## CLEVELAND NATIONAL FOREST POWER LINE REPLACEMENT PROJECTS

### MINOR PROJECT REFINEMENT REQUEST FORM

<b>Date Submitted:</b>	03-29-19	<b>Request #:</b>	030
<b>Date Approval Required:</b>	04-12-19	<b>Landowner:</b>	XXXX
<b>APN:</b>	XXX-XXX-XX		
<b>Refinement from (check all that apply):</b>			
<input type="checkbox"/> Mitigation Measure	<input type="checkbox"/> APM	<input checked="" type="checkbox"/> Project Description	<input type="checkbox"/> Drawing <span style="margin-left: 20px;"><input checked="" type="checkbox"/> Other</span>
<b>Identify source (mitigation measure, project description, etc.):</b>			
<p>Notice to Proceed (NTP) request #15 and Minor Project Refinement (MPR) request #18 for the Cleveland National Forest Power Line Replacement Projects (Project) were approved by the California Public Utilities Commission (CPUC) and the United States Forest Service on August 30, 2018. Since the approval of NTP request #15 and MPR request #18, San Diego Gas &amp; Electric Company (SDG&amp;E) has determined that a modification to the approved navigation access road to Pole P45476 is required in order to minimize impacts to sensitive resources and maintain conventional access to P

**Attachment B:  
Comparison Map  
C449 Map 1 of 1**

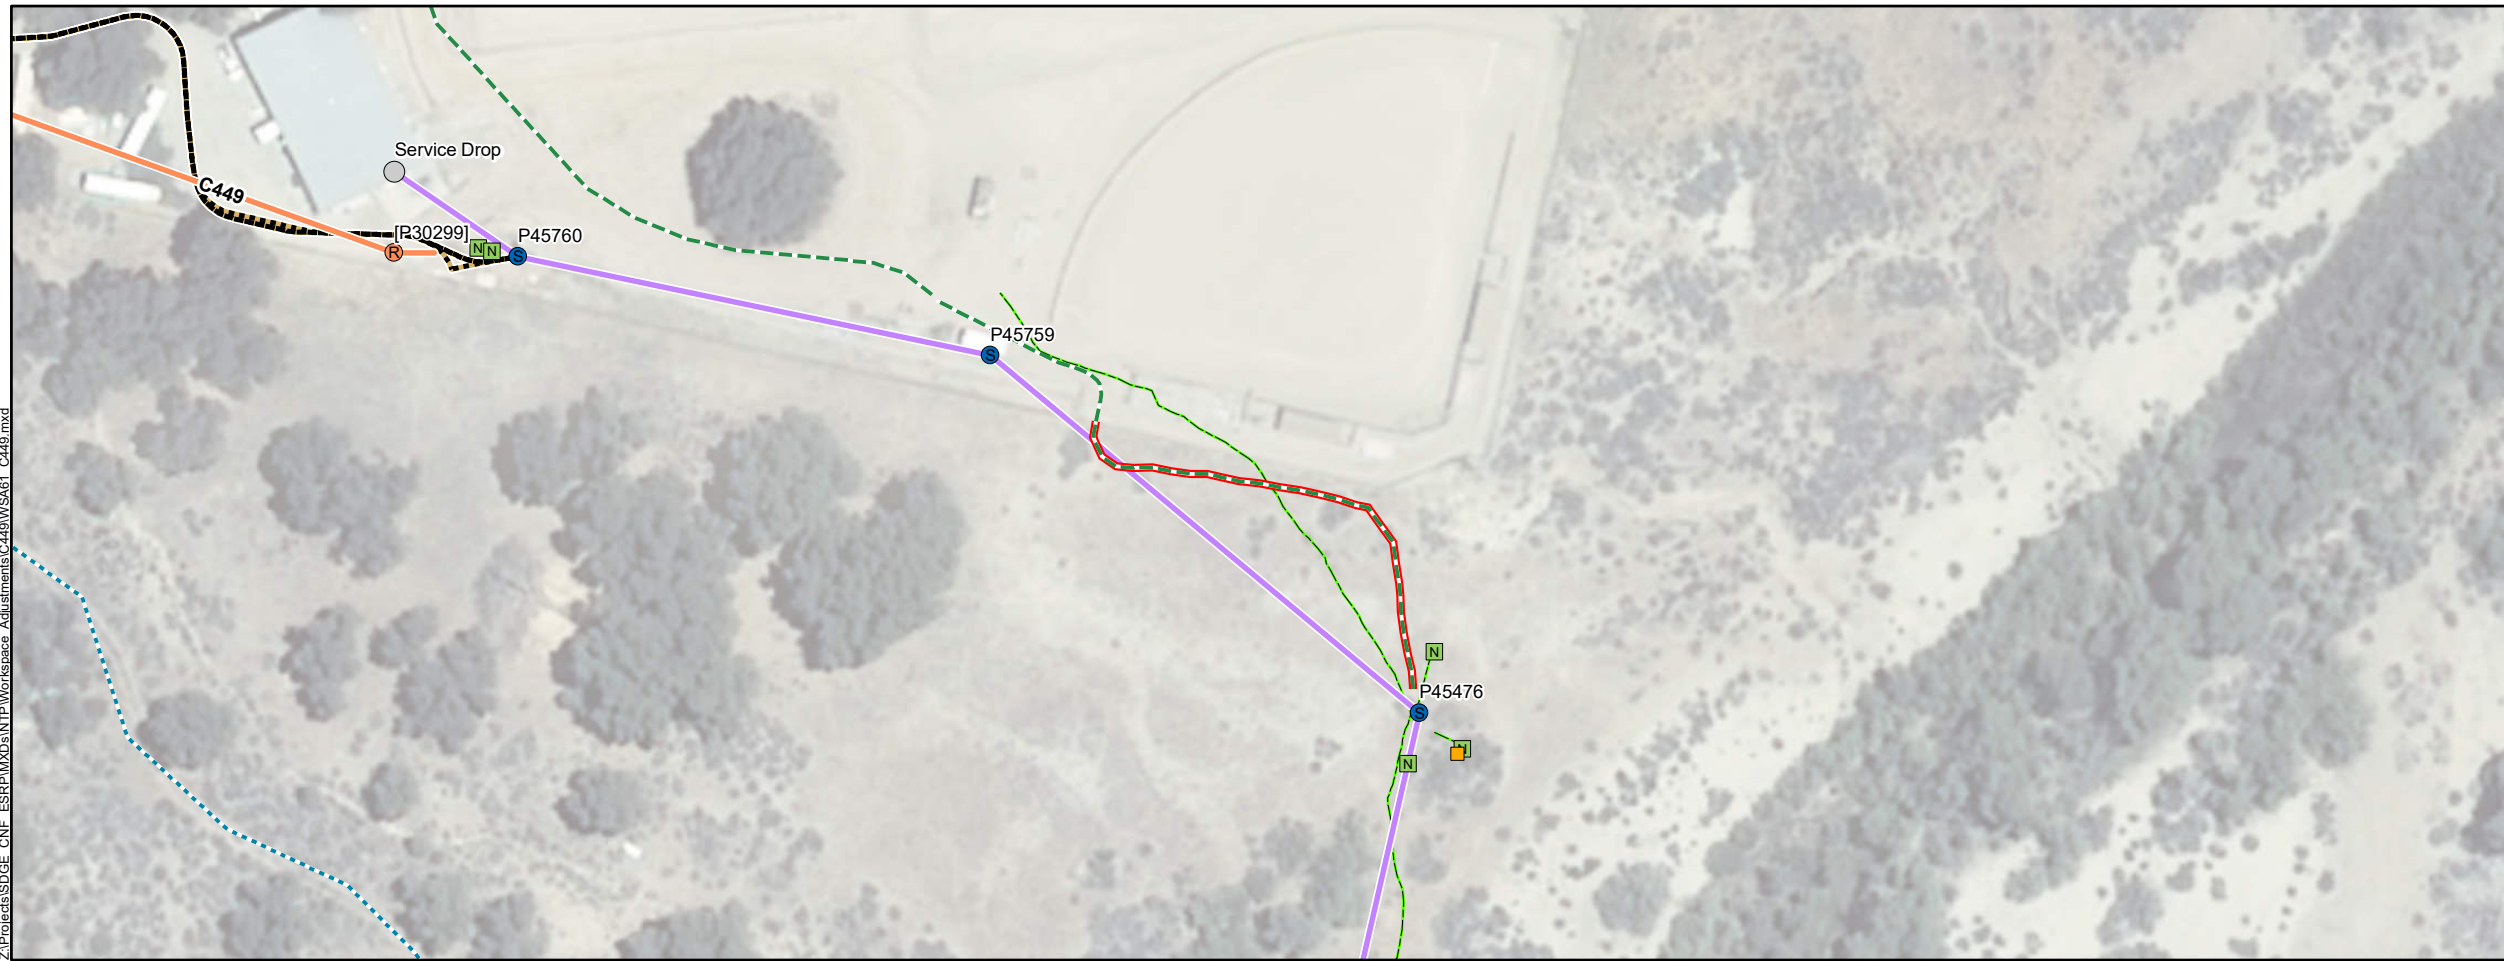
<b>(d) Does the proposed refinement trigger an additional permit requirement?</b>				<input type="checkbox"/> Yes		<input checked="" type="checkbox"/> No			
<b>Describe refinement being requested (attach drawings and photos as needed):</b>									
As depicted in Attachment B: Comparison Map and Attachment C: Photographs, SDG&E is requesting to modify the previously approved navigation access road to Pole P45476, which is an overland travel route. The modified road will begin approximately 65 feet southeast of Pole P45759 at an existing chain-link gate, then continue south for approximately 20 feet before turning east for approximately 150 feet, paralleling an existing fence line. The road will then continue south for approximately 95 feet to the temporary pole work area for Pole P45476. No vegetation clearing or grading (i.e., ground disturbance) is required for use of the modified road; however, trimming of vegetation may be required for fire mitigation. The activities associated with the modified navigation access road will occur in the same manner as described in the Final EIR/EIS for construction of the Project.

<b>Provide need for refinement (attach drawings and photos as needed):</b>									
SDG&E is requesting to modify the navigation access road to Pole P45476 in order to minimize impacts to sensitive cultural resources that were discovered within 50 feet of the approved navigation access road, as well as maintain conventional access to Pole P45476 for pole and anchor hole digging and pole setting.									
<b>Date refinement is expected to be implemented:</b>				04-13-19					
<b>Resource Agency Coordination</b>									
<b>Resource Agency</b>		<b>Name</b>		<b>Action Required</b>		<b>Date</b>		<b>Documentation (see attached if yes)</b>	
Not Applicable (N/A)		N/A		N/A		N/A		<input type="checkbox"/> Yes <input type="checkbox"/> No
